Attention to bidders of Ventura Harbor Public Boat Wash Station Replacement Project 1400 Anchors Way Dr., Ventura, California. Note, this is the fourth addendum for the rebid.

Addendum No.4: Responses to Requests For Information (RFI's)

NEW BOAT WASH FOR VENTURA PORT DISTRICT
1404 ANCHORS WAY
City of Ventura
COUNTY OF VENTURA STATE OF CALIFORNIA

WASH STATION SPECS

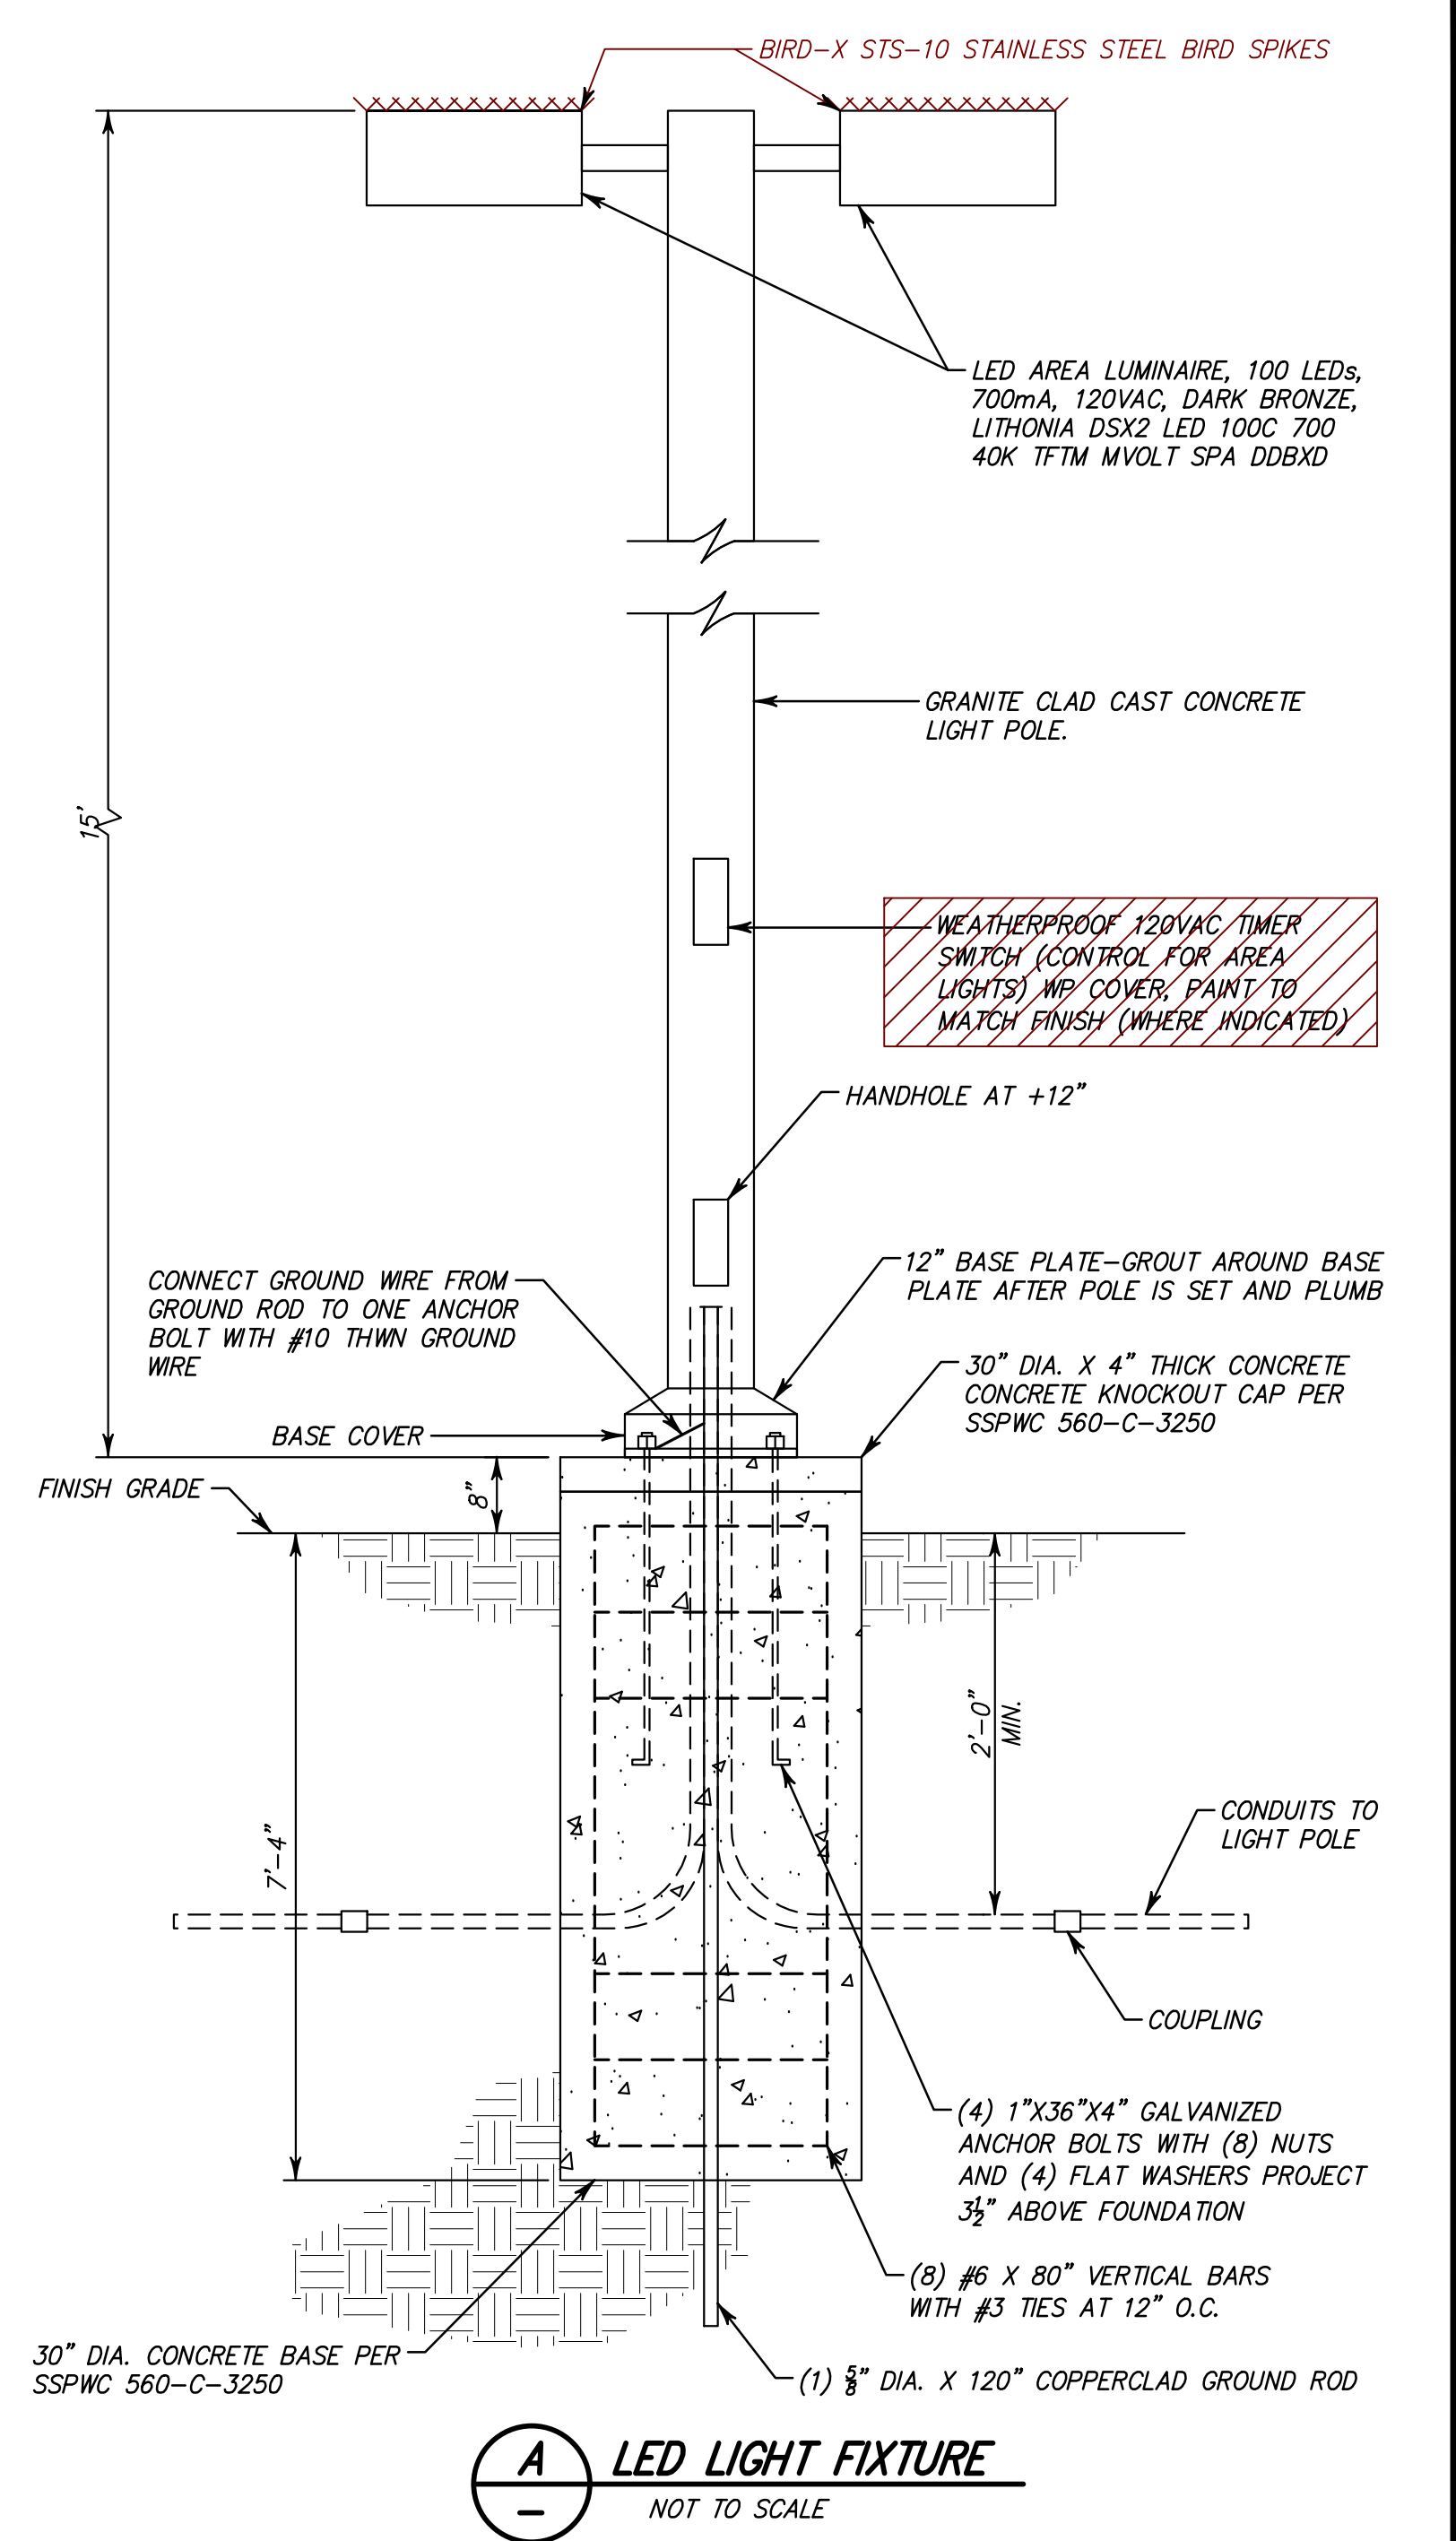
Wash station model number is now 77555 and adding part No. 69-01245 for boat motor wash pump system. Also add Card Reader Payment System.

1. Stainless Steel Cabinet
2. MARINE ENGINE FLUSH -
3. High Pressure Wash/Rinse/
4. Colorful Instruction Sign
5. One 1/4" x 45 High Pressure Hose
6. Pre-wired & Pre-plumbed
7. Trigger Gun and Stainless Steel Spray Tip
8. Eight Position Rotary Selection Switch
9. Removable Access Door
10. 3 HP 3 PH Electrical Motor
11. Cat SCP2120 Pump
12. Belt-driven System
13. VOLTAGE: 220 CYCLES 60 PHASE 3
14. ADA COMPLIANT
15. SUPPLY TWO EXTRA WANDS AND PRESSURE HOSES PER WASH BOX.
16. ADD COLEMAN PART NUMBER 69-01245 FOR BOAT MOTOR WASH PUMP SYSTEM
17. ADD CARD READER PAYMENT SYSTEM
